Assessment of InfoToGo Pillar Design Modification vs. Vibrant Streets Guidelines

Attachment 1: Spot the difference...Megabin vs InfoToGo Pillar...

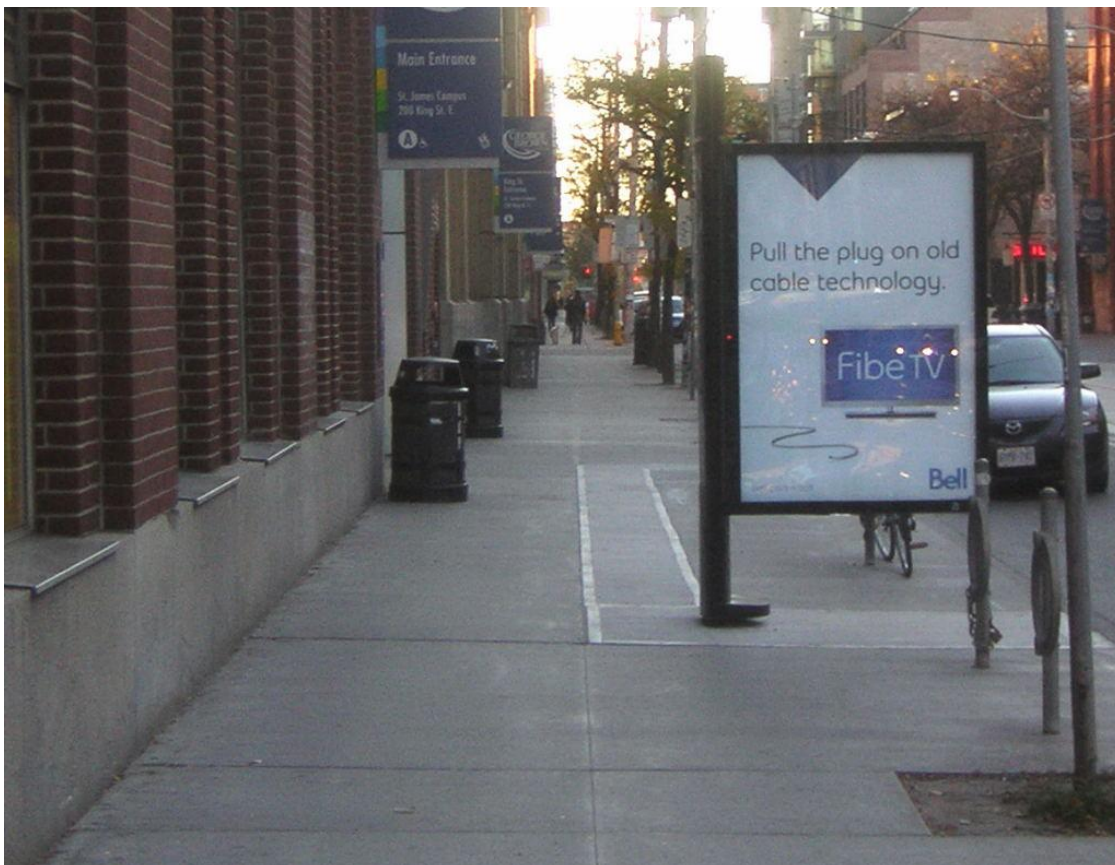
The vilified Megabin -- with garbage/recycling slots at the end of a billboard...

The proposed InfoToGo Pillar – with 'way-finding' info at the end of a billboard...
